APPLICANT: Consumers Power Company  
FACILITY: Midland Plant, Units 1 and 2  
SUBJECT: Summary of September 8, 1981 Meeting on Seismic Input Parameters

On September 8, 1981, the NRC staff met in Bethesda, Maryland with Consumers Power Company (the applicant) to discuss Part III of a report on the Midland site specific response spectra, "Seismic Hazard Analysis", February 1981. Staff review of this report was requested by the applicants letter of August 11, 1981. Also represented were members of the applicants consultant, Westco Geophysical Corporation. Meeting attendees are listed by Enclosure 1. The meeting agenda consisted of nine questions raised by the staff during its review and attached to the September 8, 1981 meeting notice.

Attachment  
Midland Nuclear Plant  
Draft Agenda for Meeting on Part III  
Seismic Hazard Analysis

FIGURE Q2-6

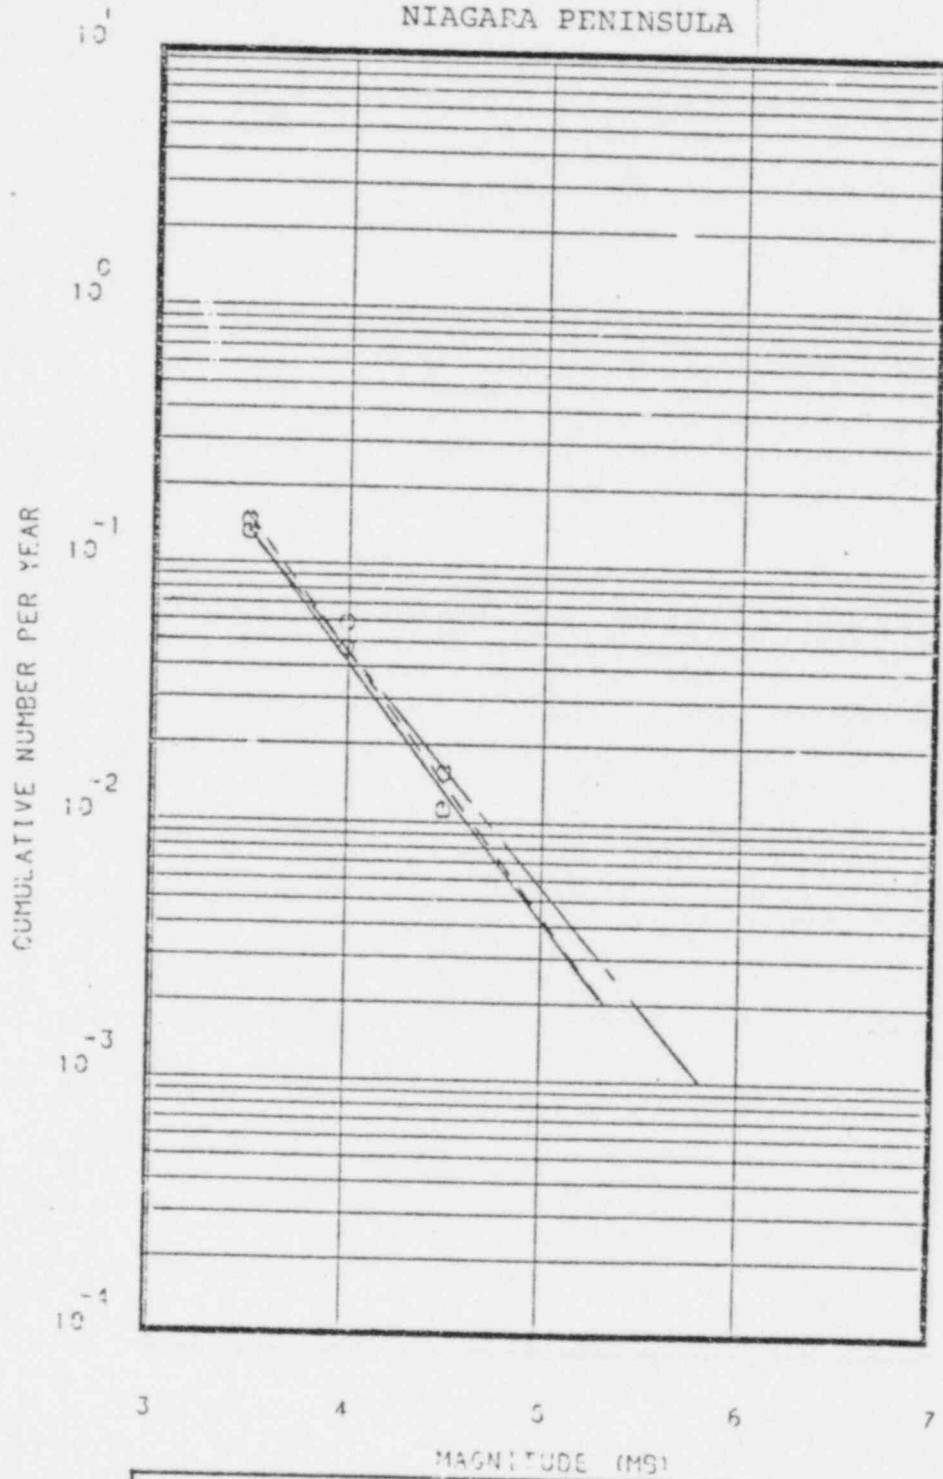
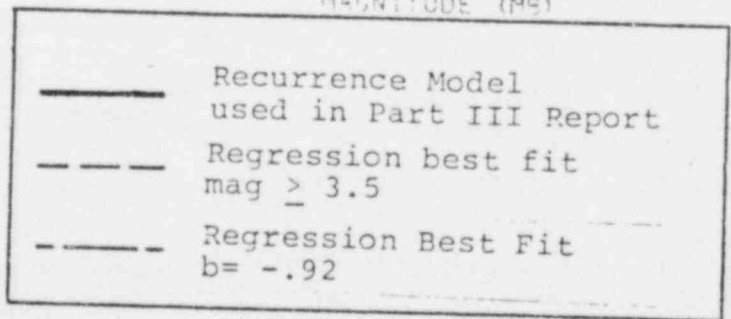
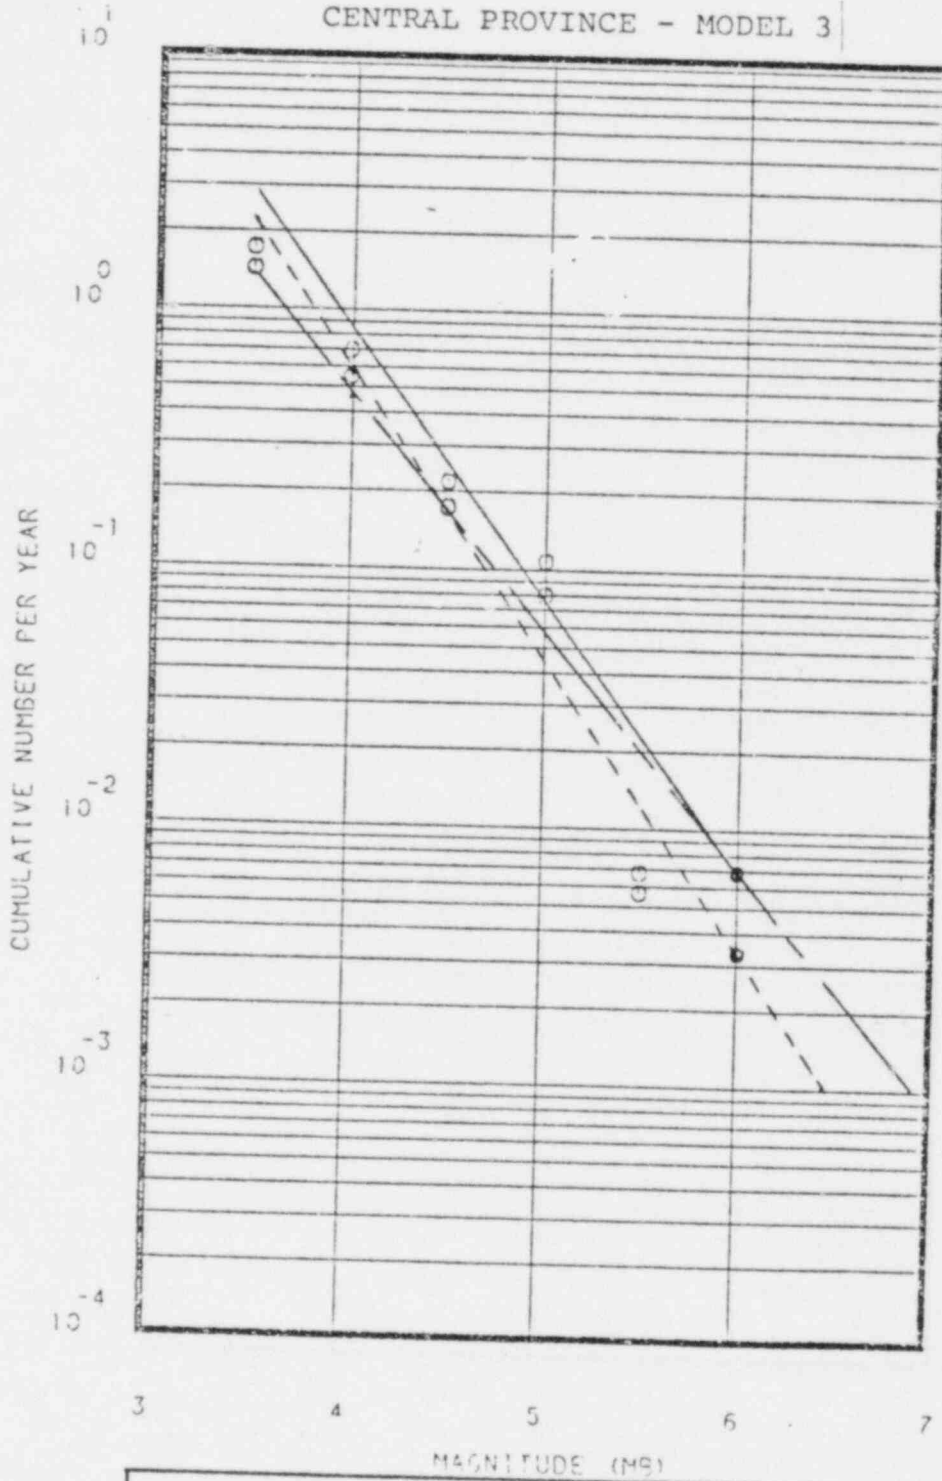
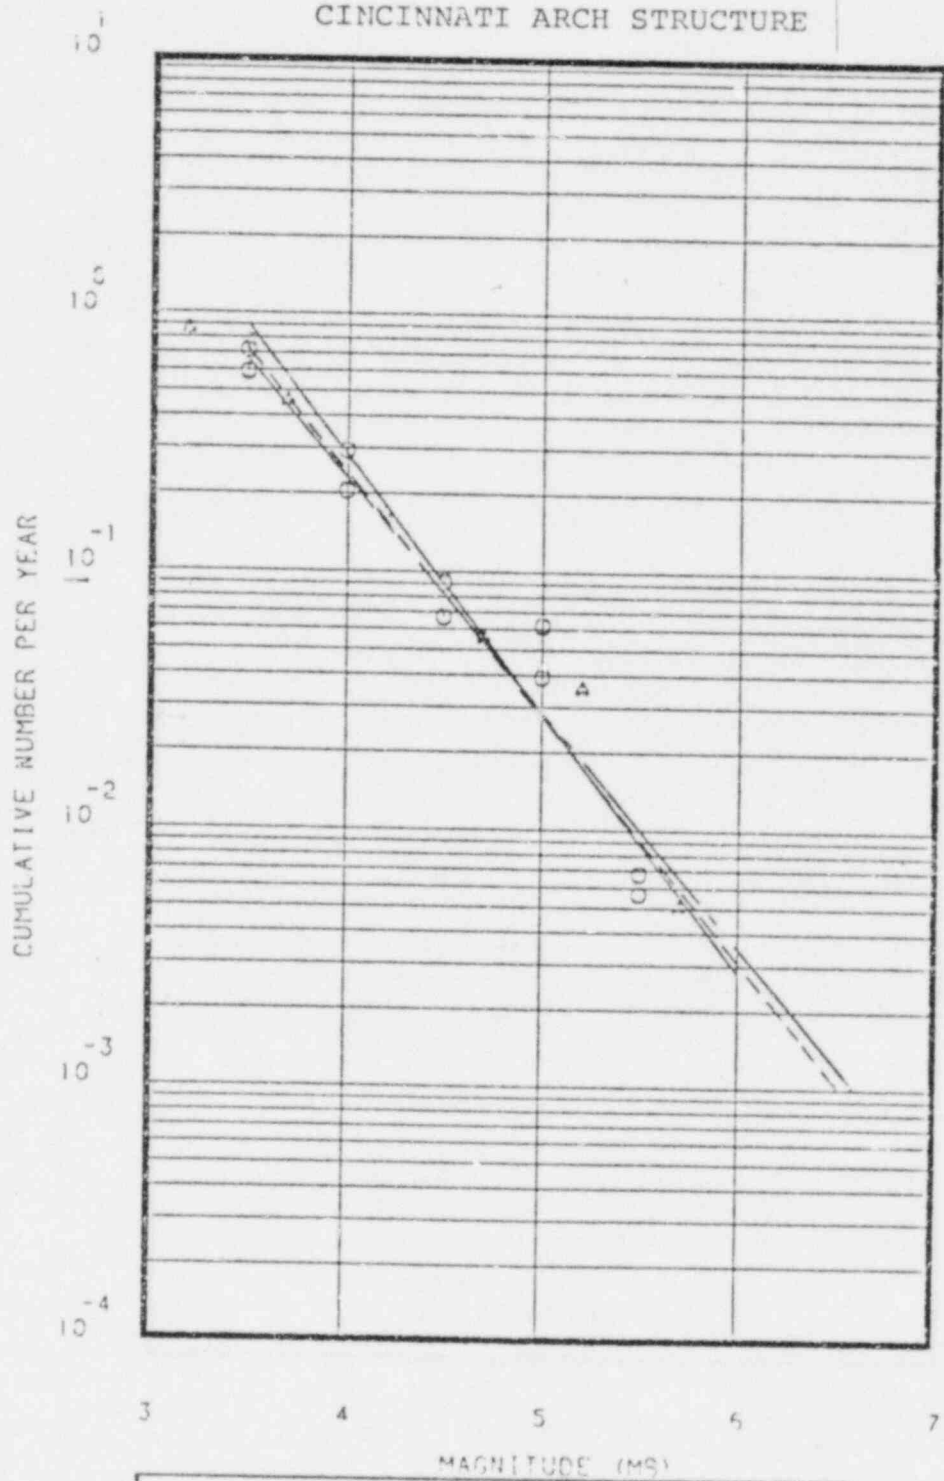
2. Provide plots of the annual number of earthquakes versus magnitude (it is not necessary to normalize to a uniform area) for all source zones similar to figures 5-8. These plots should show the actual data points along with the regression best fit line.

——— Recurrence Model  
 used in Part III Report  
 - - - - Regression best fit  
 mag  $\geq$  3.5  
 - · - · Regression Best Fit  
 b =  $-.92$

Figure Q4-C1

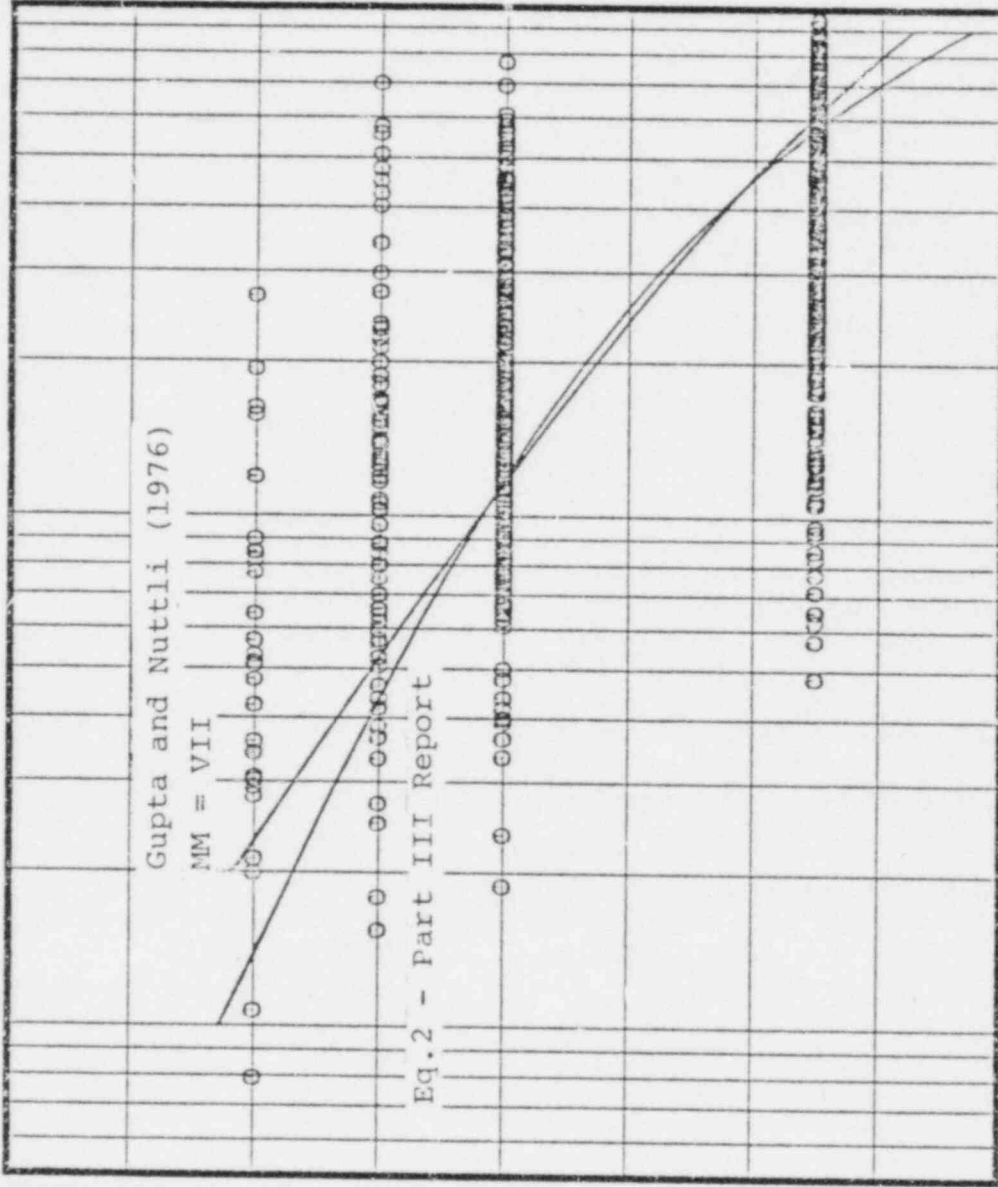
- b) limiting the likelihood of certain intensities for the maximum magnitude
  - c) using a different attenuation relationship such as Gupta and Nuttli (1976) which has a different estimate of standard deviation of intensity.
